ASSESSMENT REPORT

Section 75W Modification Huntlee New Town Stage 1 (MP10_0137 MOD 3)

Figure 4: Proposed Huntlee Stage 1 Site Wide Master Plan

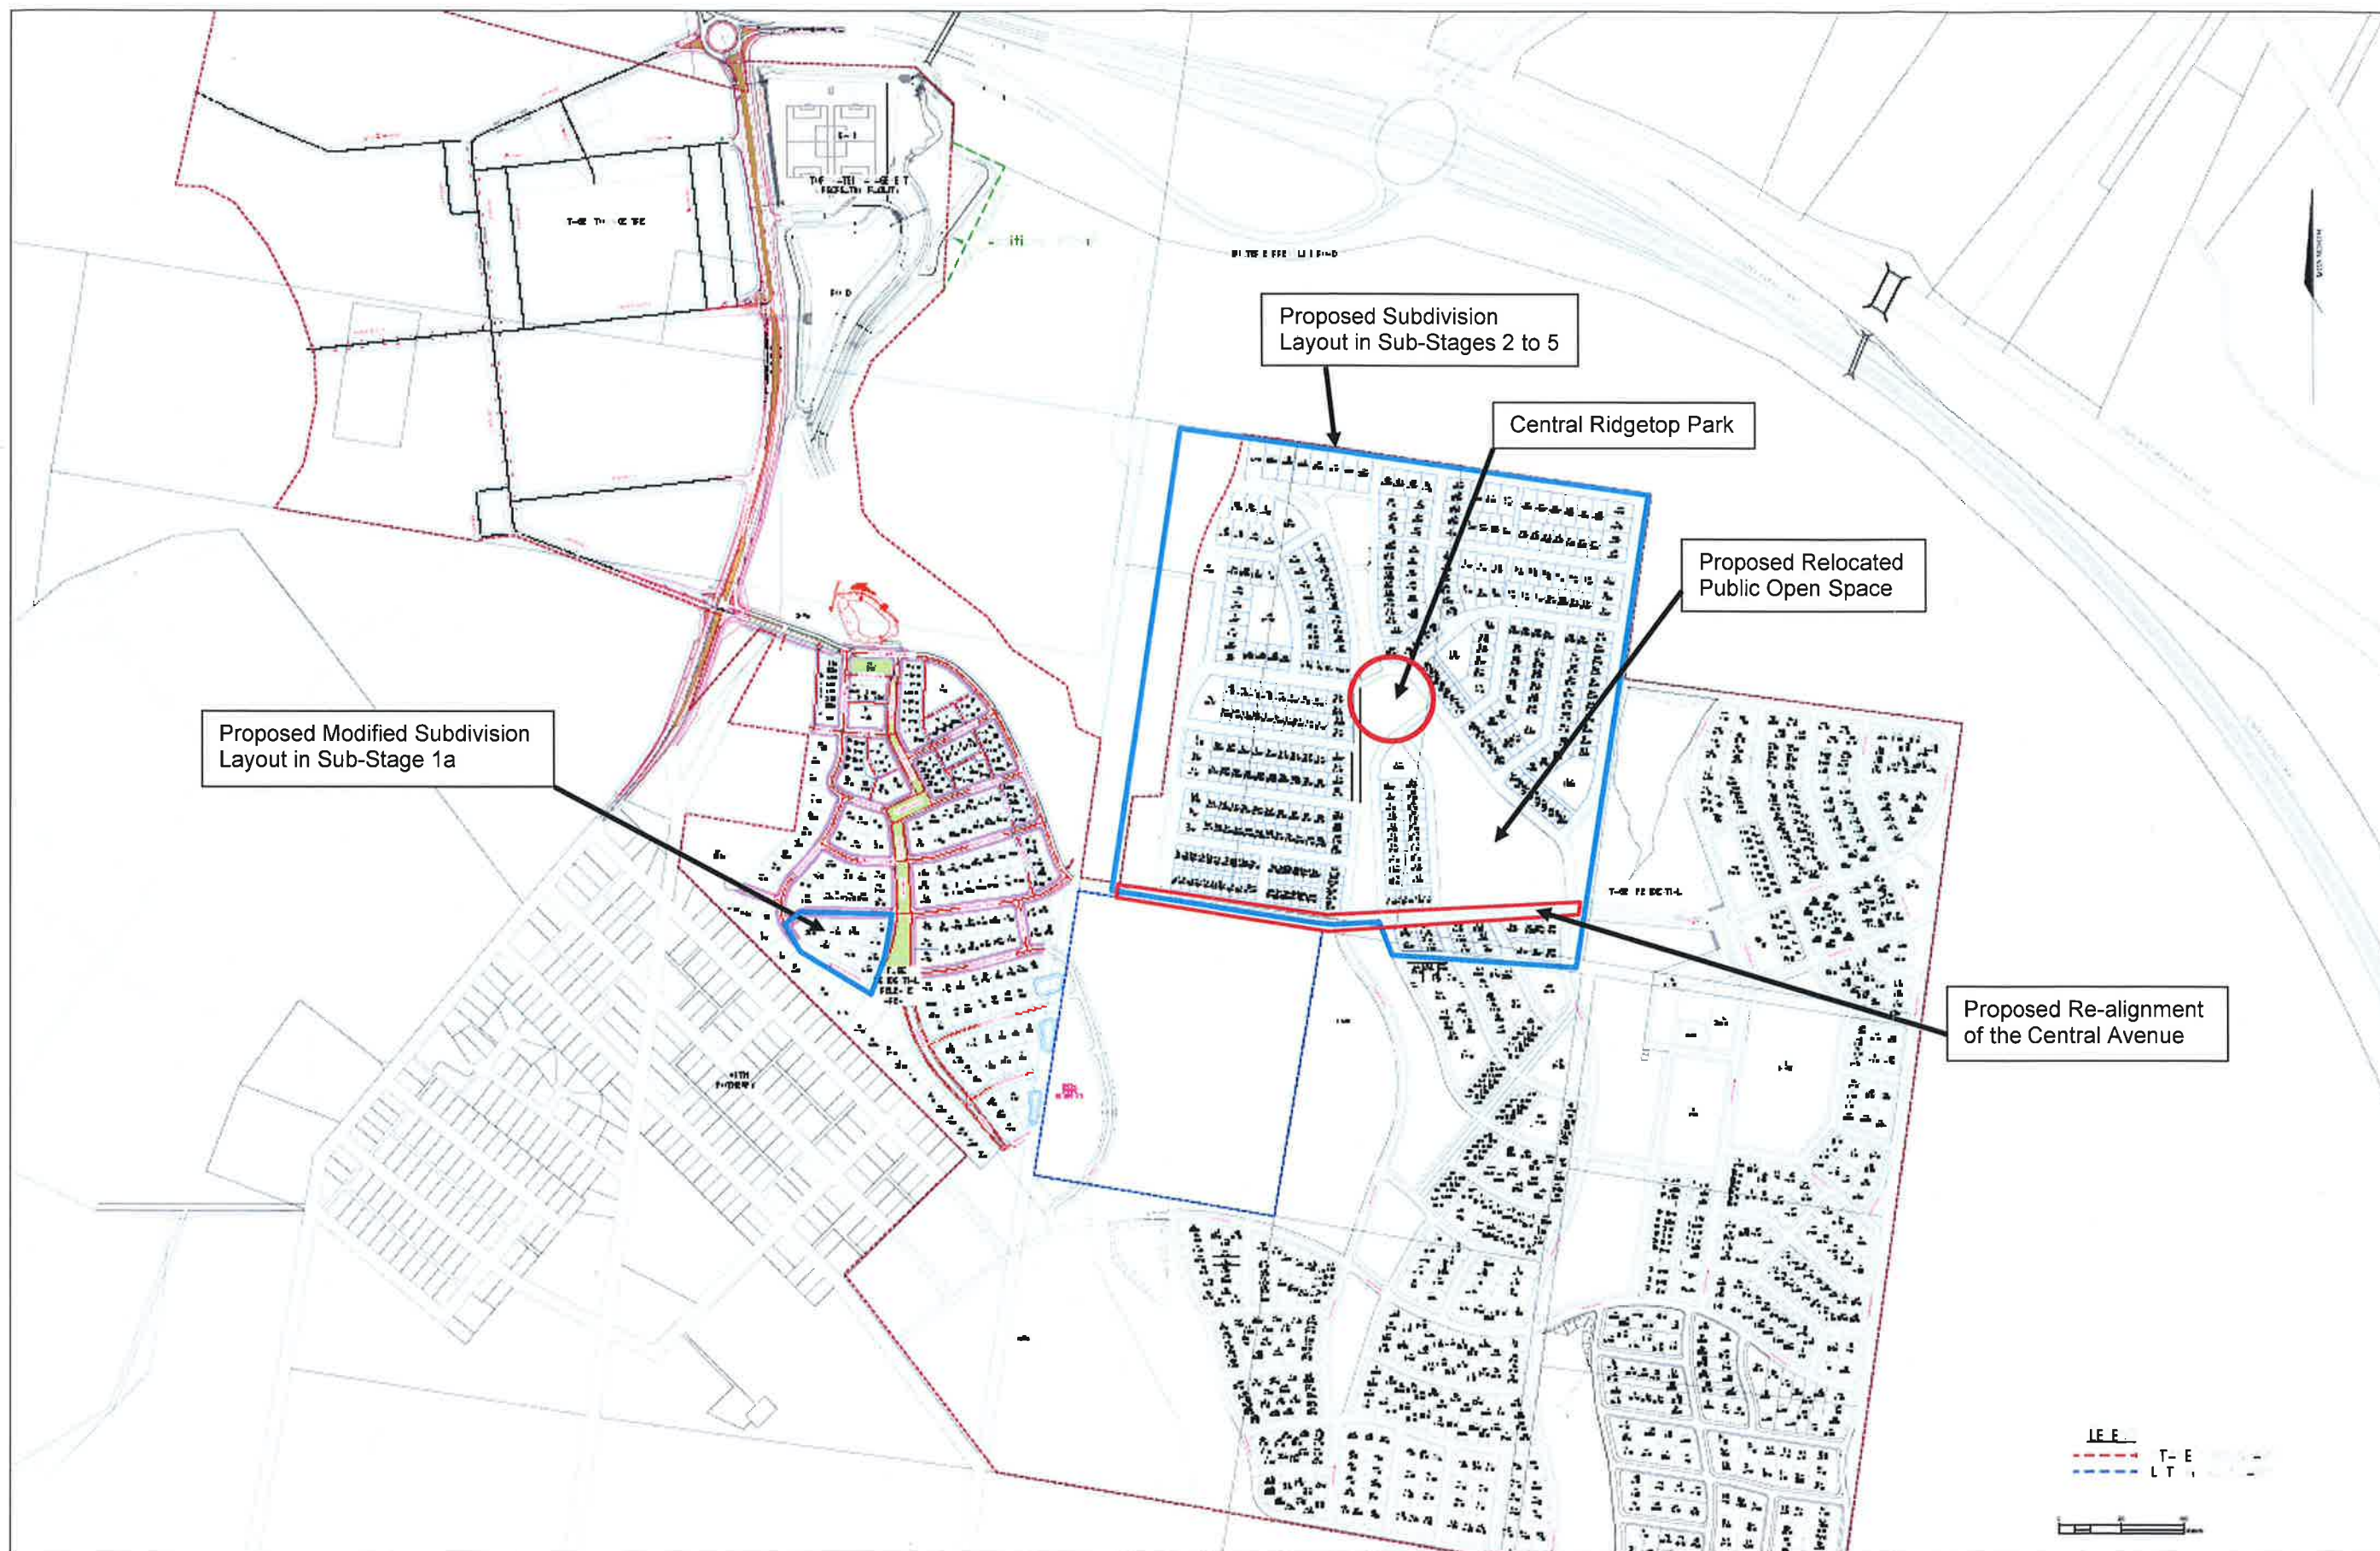
The modification request seeks to relocate the proposed sports ground from sub-stage 4, further to the south within sub-stage 5, to improve its proximity and connectivity to the Village Neighbourhood Centre and the Central Ridgetop Park (**Figures 4 and 5**). The Proponent has demonstrated that the total open space area (82.5 Ha) remains identical to that approved under the original Project Approval.

The Department is satisfied that the relocation of the open space in sub-stages 2 to 5 would provide a superior outcome compared to the original open space configuration, as it would:

Figure 6: Proposed Subdivision Layout for Sub-Stages 2 to 5

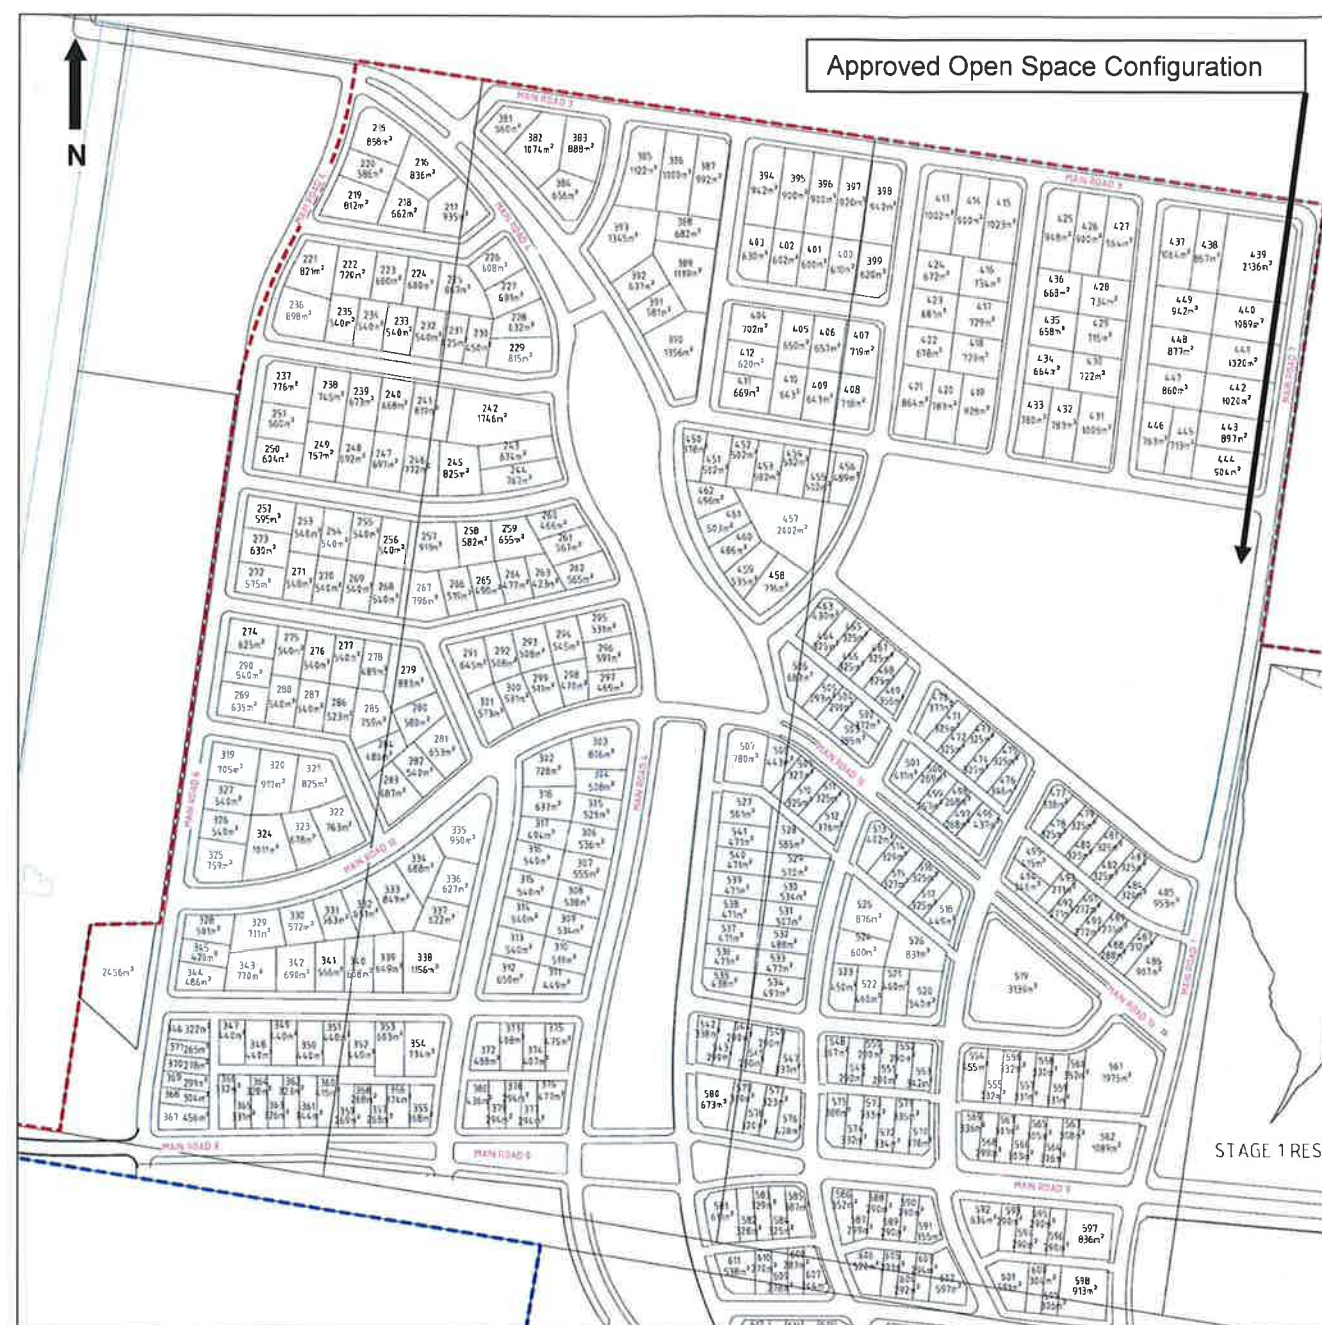
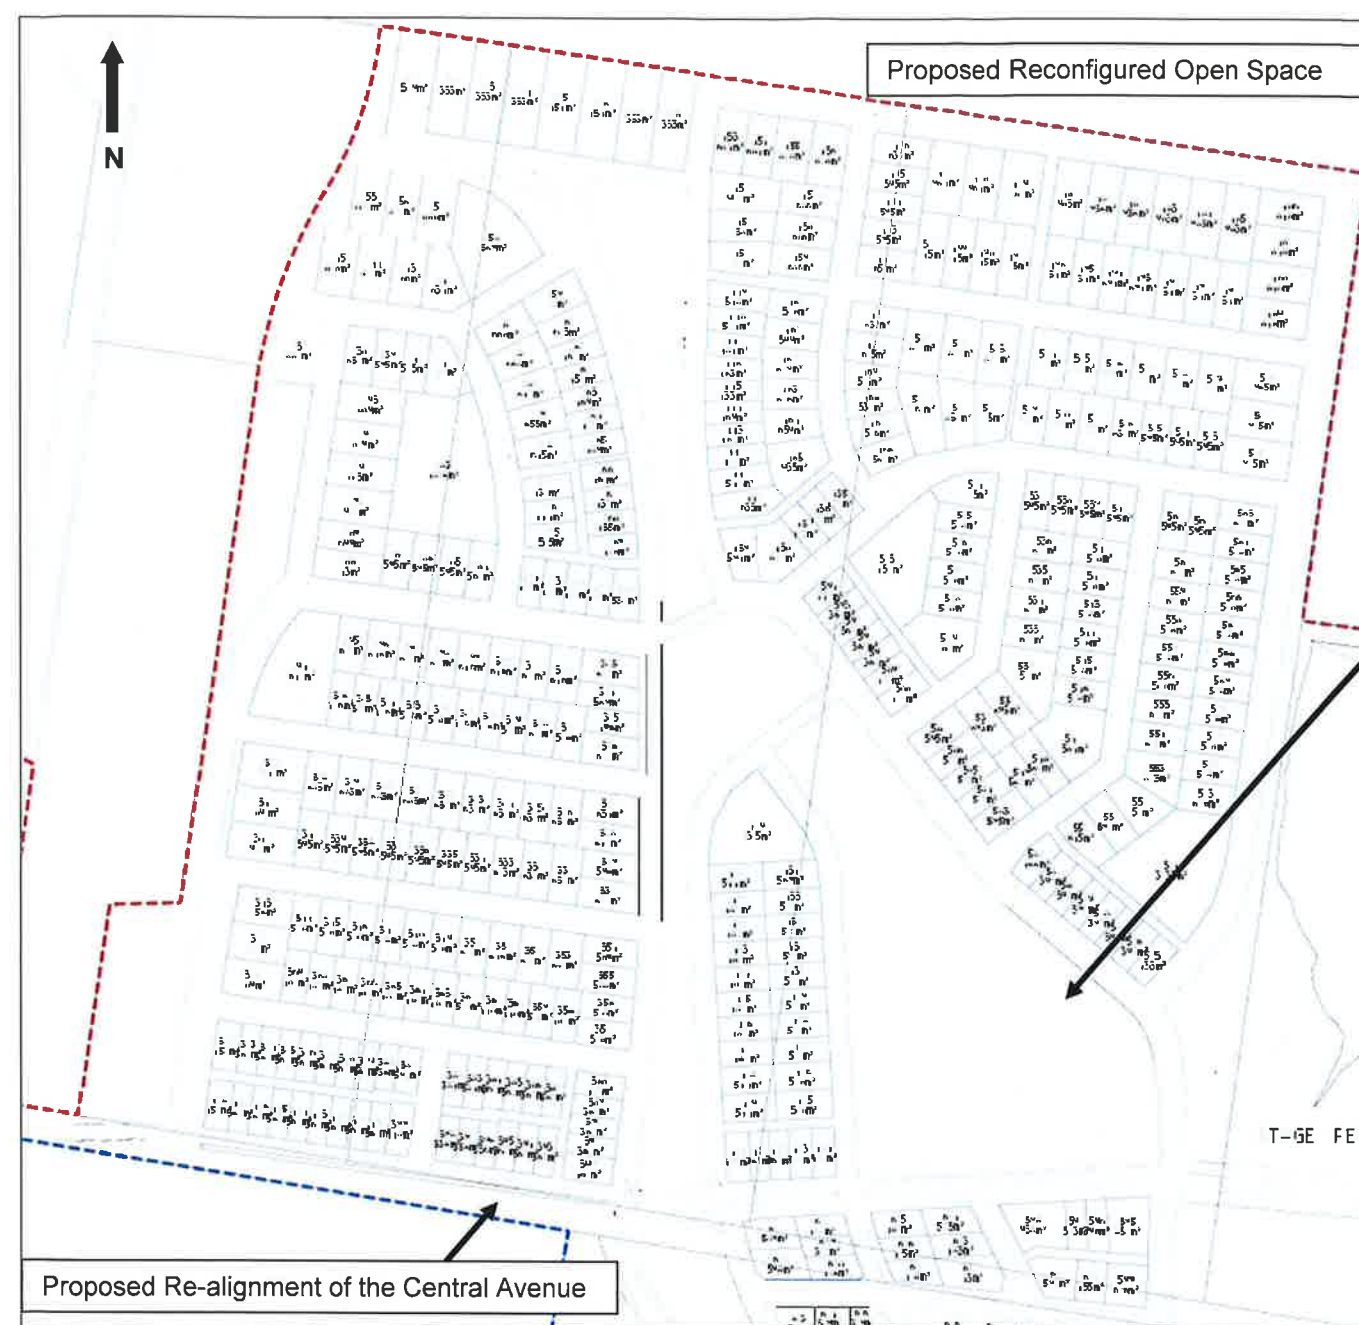
The modification request seeks approval to amend the subdivision and road layout of lots contained within sub-stages 2 to 5 within the main Stage 1 Project Approval area. Note: the proposed changes do not apply to that part of sub-stage 5 known as 'Hanwood' which is in an isolated location south of the main Stage 1 area (**Figure 2**).

- revised road layout including re-alignment of Central Avenue;
- revised residential lot layout;
- revised sub-stage boundaries including the boundary with sub-stage 8;
- reduction in the number of residential allotments (by 27 lots within sub-stages 2 to 5 and sub-stage 8); and
- relocation of the open space area from sub-stage 4 to the south to sub-stage 5.

The Department has assessed the revised subdivision and road layout against Section 4 of the Huntlee DCP. The Department's assessment of the modification request against the relevant controls of the DCP is located at **Appendix A**. The proposed subdivision amendments remain generally consistent with the objectives of Section 4 of the DCP as the revised layout:

Council raised no concern with the revised subdivision layout subject to laneway access being maintained for the small lots adjacent to Central Avenue. As demonstrated in **Figure 9** above, the small residential lots adjacent to Central Avenue retain laneway vehicle access.

Overall, the Department is satisfied that the amended layout is generally consistent with the Huntlee DCP, would improve connectivity by creating a more linear street grid with reduced road lengths, and would not result in any detrimental impacts for the operation of the road network. On this basis, the Department considers the inclusion of the revised site-wide Masterplan, and revised subdivision layout for sub-stages 2 to 5 in Condition A2 is acceptable.

Figure 10: Revised Stormwater/Flooding Plan for Sub-Stages 2 to 5

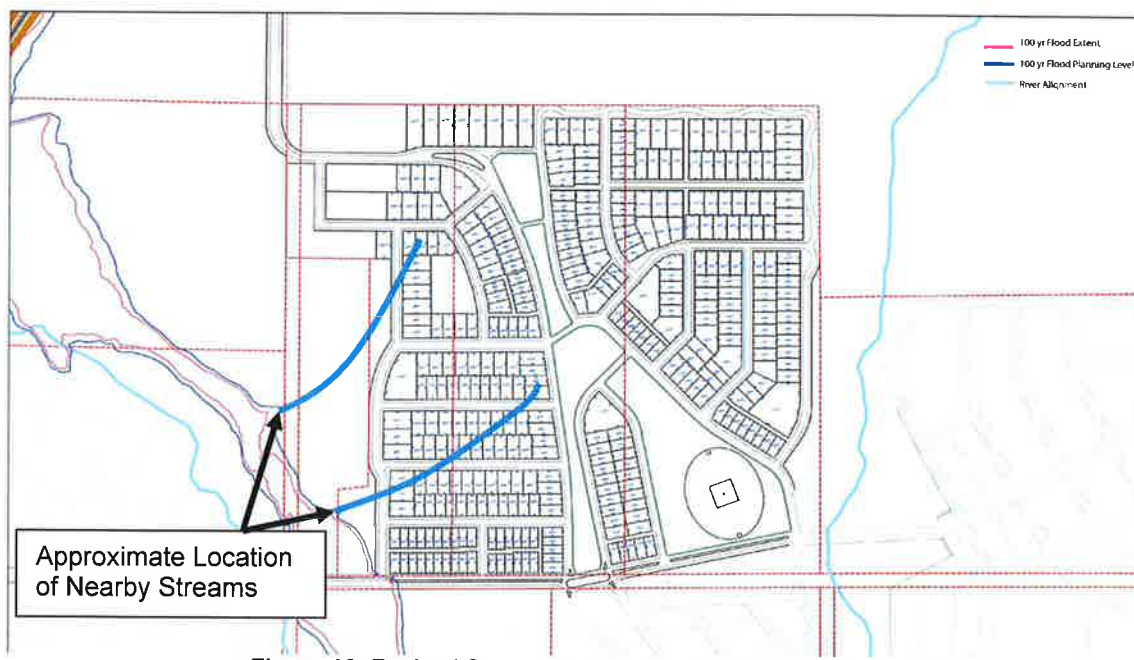
Council raised concern regarding the potential stormwater impacts on lots within sub-stages 2 and 3 located nearby two first order streams (**Figure 10**). Council advised that the Proponent would need to demonstrate that the proposed subdivision layout could be engineered to mitigate stormwater flows so no burden is placed on Council or future landowners.

To address Council concerns, the Proponent advised that the subdivision is to incorporate stormwater management infrastructure including:

- road grading to convey overland stormwater flows to the west and then to the south to the approved bio-retention and stormwater management systems;
- formalised curb and guttering altering the overland flow path; and
- inter-allotment drainage lots without gravity drainage to the street to limit stormwater flows across properties.

Council has confirmed that this combination of infrastructure for stormwater management is likely to be sufficient to reduce the impact of the proposed subdivision layout. However, Council requested that detailed engineer's drawings of the overall stormwater management scheme be provided in order to confirm that the proposal would not impede the future

However, as the stormwater management scheme for lots associated with the two streams may have implications for Council's long-term management of stormwater in the area, it is considered reasonable that the stormwater management scheme for this part of the site, be designed to the satisfaction of the Council prior to the issue of a Construction Certificate. An additional condition to this effect is therefore recommended to be included in the Notice of Modification accordingly.
